Access Compliance Report

Public Rights-of-Way

(Curb Ramps)

Intersection ID: 30211	Main Street: BRISTLE_LN	Cross Street: HIDDEN_CREEK_DR	Location: E
ADA ID: 9DDF686013B1	Ramp Type: Perp	Initial Pass/Fail: Fail	Overall Compliance: No
Severity Score: 12.5			
Codes/Mitigation Info/Possible Solution		Field Measurements/Component Compliance

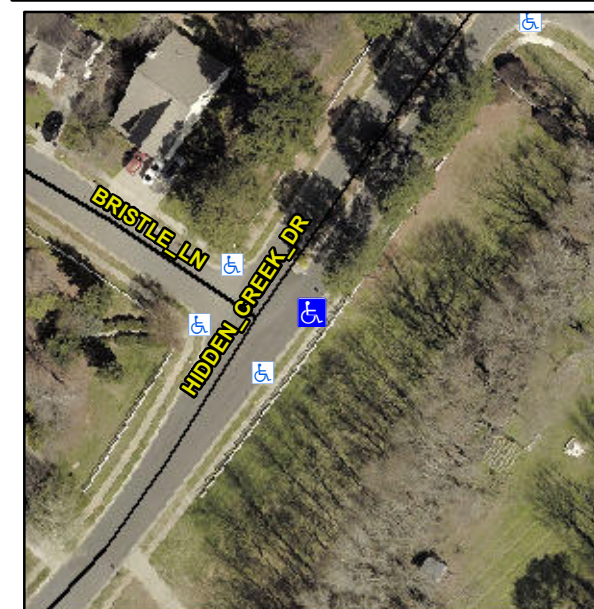
Compliance	Description	Data	Compliance	Description	Data
N/A	Ramp Length (in)	47.0	No	Ramp Slope (%)	10.2
Yes	Ramp Width (in)	49.5	Yes	Ramp XSlope (%)	0.2
N/A	Flare Type LT	N/A	N/A	Flare Type RT	N/A
N/A	Flare Slope LT (%)	N/A	N/A	Flare Slope RT (%)	N/A
N/A	Flare Traversable LT?	N/A	N/A	Flare Traversable RT?	N/A
N/A	Landing Length (in)	N/A	N/A	DWS Provided?	N/A
N/A	Landing Width (in)	N/A	N/A	DWS Contrast?	N/A
N/A	Landing Slope (%)	N/A	N/A	DWS Length (in)	N/A
N/A	Landing X Slope (%)	N/A	N/A	DWS Full Width?	N/A
N/A	Landing Curb? (Y/N)	N/A	N/A	DWS Offset (in)	N/A
N/A	Shared Landing?	N/A			
N/A	Gutter Ponding?	N/A	N/A	Gutter Slope (%)	N/A
N/A	Gutter Lip Ht (in)	N/A	N/A	Gutter X Slope (%)	N/A
N/A	Painted X Walk1?	No	N/A	Painted X Walk2?	N/A
	X Walk 1 Direction	To NW		X Walk 2 Direction	N/A
N/A	X Walk 1 Width (in)	N/A	N/A	X Walk 2 Width (in)	N/A
	X Walk 1 Slope (%)	2.8		X Walk 2 Slope (%)	N/A
	X Walk 1 X Slope (%)	2.3		X Walk 2 X Slope (%)	N/A

Remove & Replace Entire Ramp.
